Re: D.T.E. 04-71, Boston Edison Company d/b/a NSTAR Electric, Responses to the
Department's First Set of Information Requests

D.T.E. 04-71
Information Responses

D.T.E. 04-71

D.T.E. 04-71; Attachment DTE-E-25a Magnetic Flux Density (mG) - Off Peak Loading (Existing & Proposed Configuration)

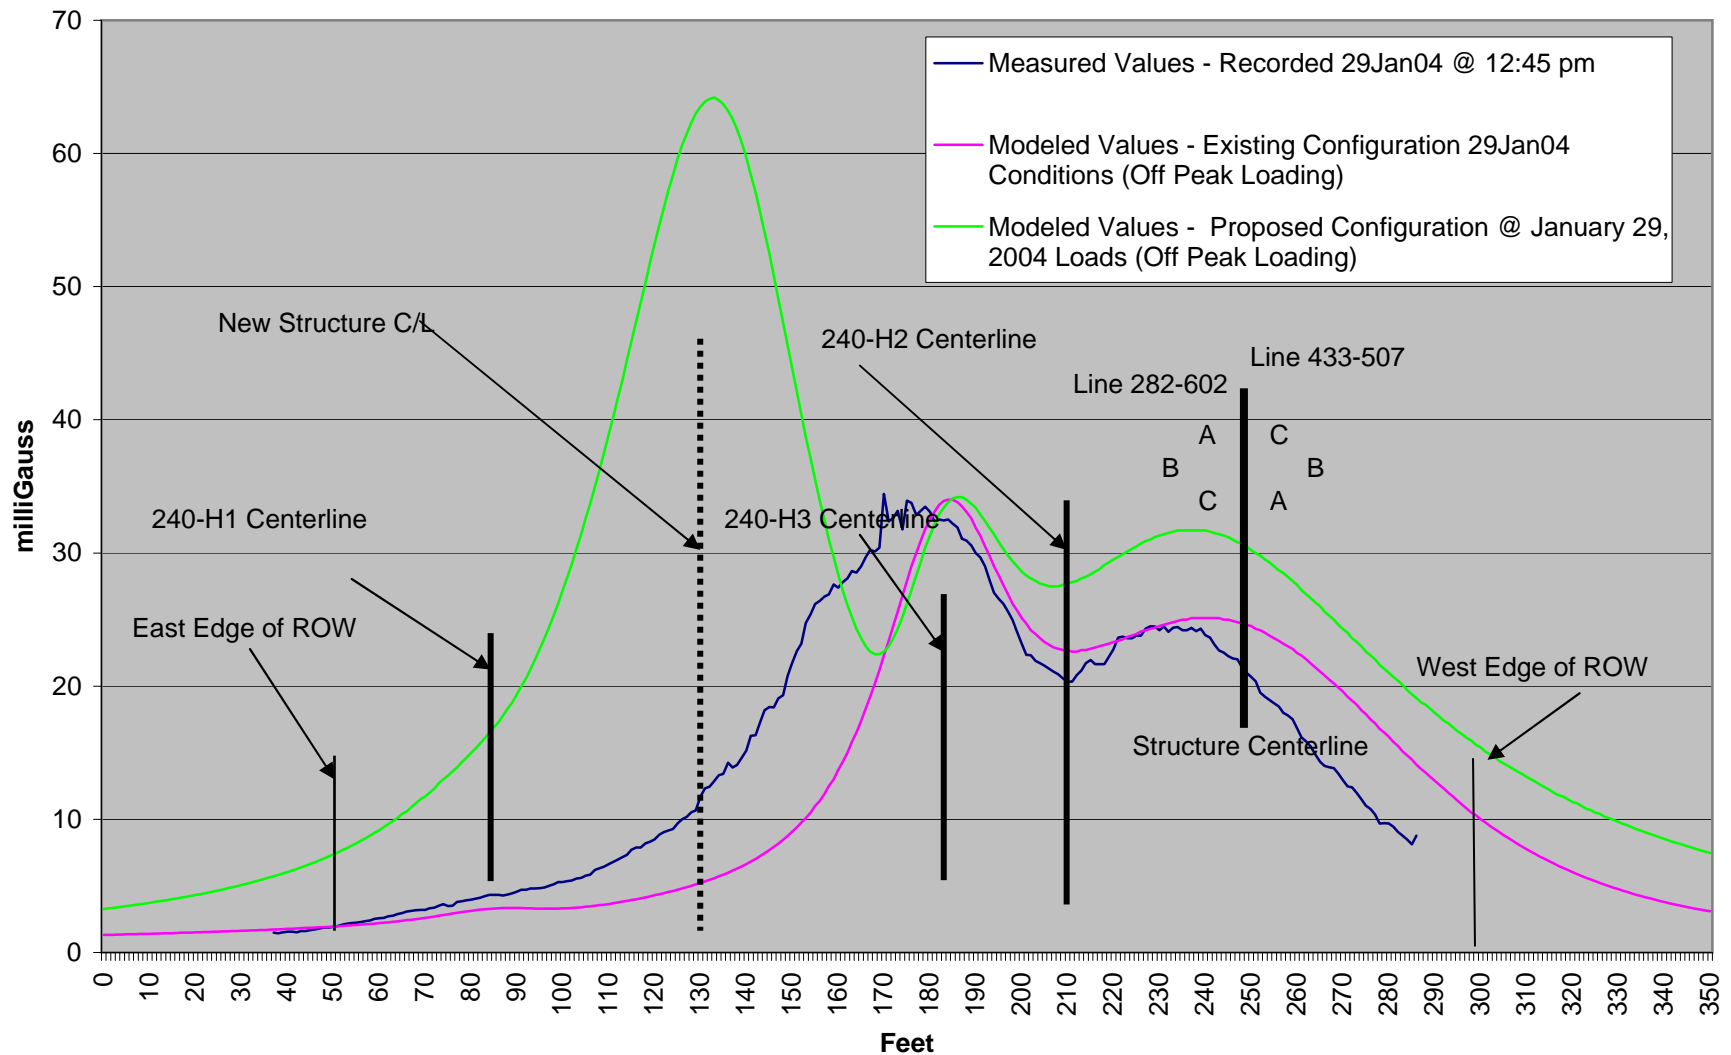
Please provide cross-sectional graphs of the information provided in the response to DTE-E-22, parts a and b, presented so that current and future configurations can be directly compared, specifically by providing: (1) one graph showing (a) measured values, (b) modeled values for off-peak loading under the existing configuration, and (c) modeled values for off-peak loading under the proposed configuration; and (2) a second graph showing (a) modeled values for peak loading under the existing configuration, and (b) modeled values for peak loading under the proposed configuration.

Please refer to the cross-sectional graphs provided in Attachments DTE-E-25a and DTE-E-25b.
